OHIO ENVIRONMENTAL PROTECTION AGENCY

DECISION DOCUMENT  
FOR THE

SHIELDALLOY METALLURGICAL CORPORATION SITE  
CAMBRIDGE, OHIO

April 1, 1997

Figure 8. Cross sections of caps.

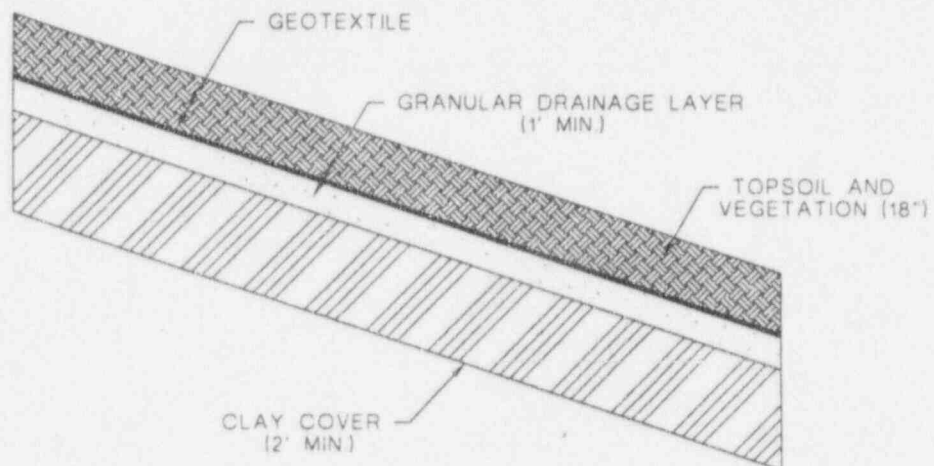
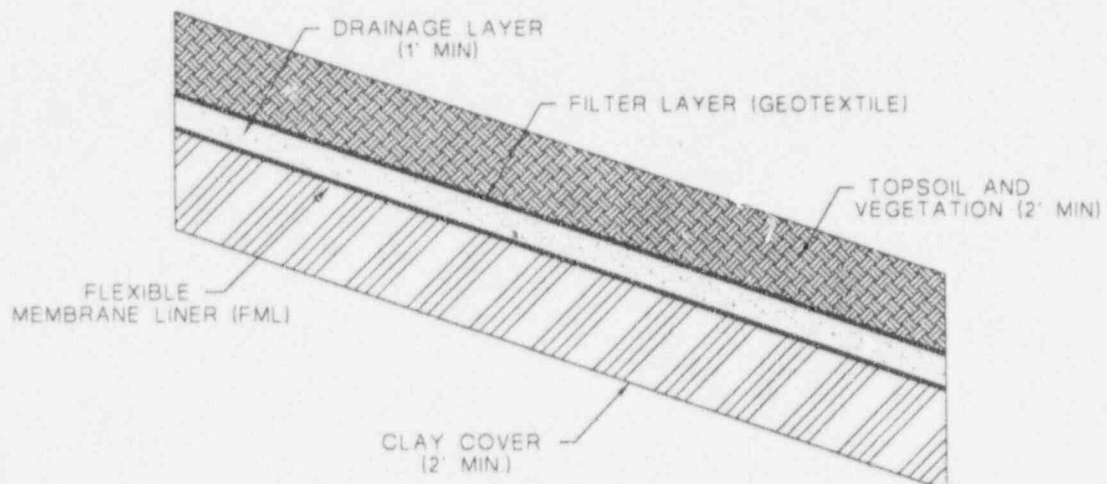
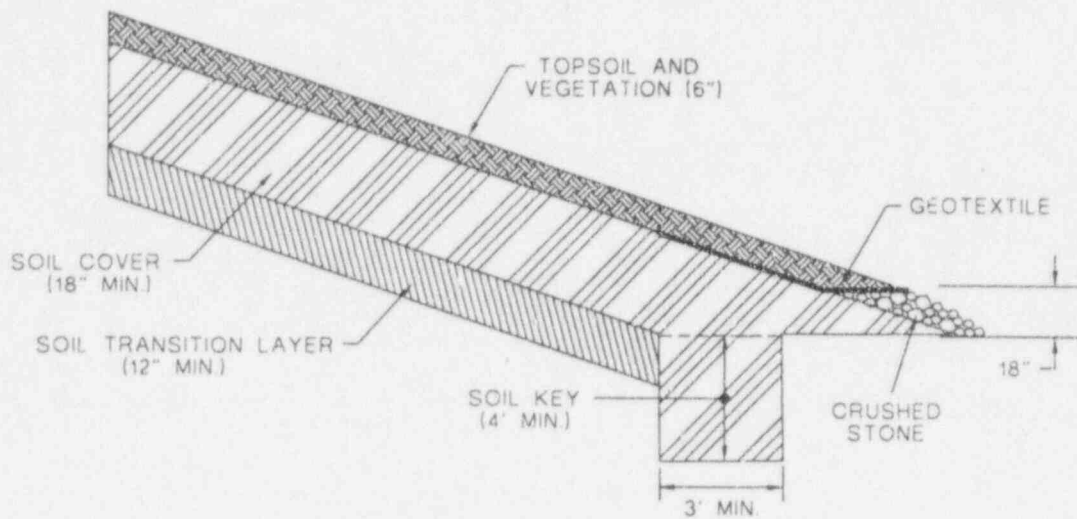
26. Comment: 5.1.2, Decommissioning Cap, page 27, lines 39 through 41: SMC and CFM note that this paragraph inaccurately describes the completion of the decommissioning cap. First, the words "baghouse dust" should be deleted from this sentence because this material was converted into Chemfix®, which then was used for the existing decommissioning cap. Second, line 41 should be replaced with "the new clay layer that extends from the Chemfix® layer down to ground surface, followed with 12 inches of top soil placed over the entire pile. (See Figure 8)."

"Completing the decommissioning cap would first require placing clay around the perimeter of the West Slag Pile. The new clay layer would have a thickness of 3 feet with a permeability  $10^{-6}$  to  $10^{-8}$  cm/sec and would extend from the edge of the Chemfix/baghouse dust layer down to ground surface, followed with 12 inches of silty sand and geotextile fabric. Upon completion of the capping of the perimeter, 9 inches of top soil would be placed over the entire West Slag Pile. (See Figure 8)"
